TO: Design Review Commission
FROM: Sierra Davis, Assistant Planner
SUBJECT: 13-SC-10 – 691 Benvenue Avenue

Continue the design review application 13-SC-10 subject to recommended direction.

This is a revised design review application for a two-story residence.

Re: New residence
691 Benvenue Avenue
Los Altos, CA
Response to Staff Incomplete letter

3.1 Plan, with tree numbers added

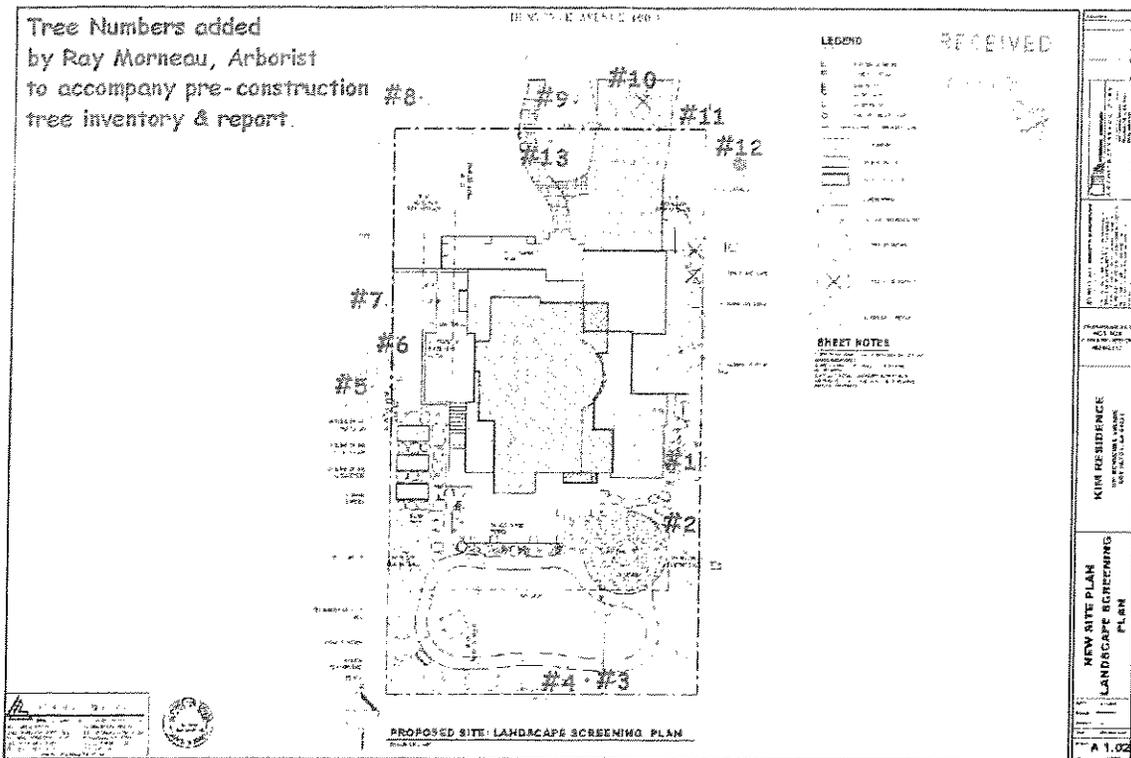
All the trees, except magnolia #10 in the new driveway footprint, can be preserved, per current site plan, A 1.02.
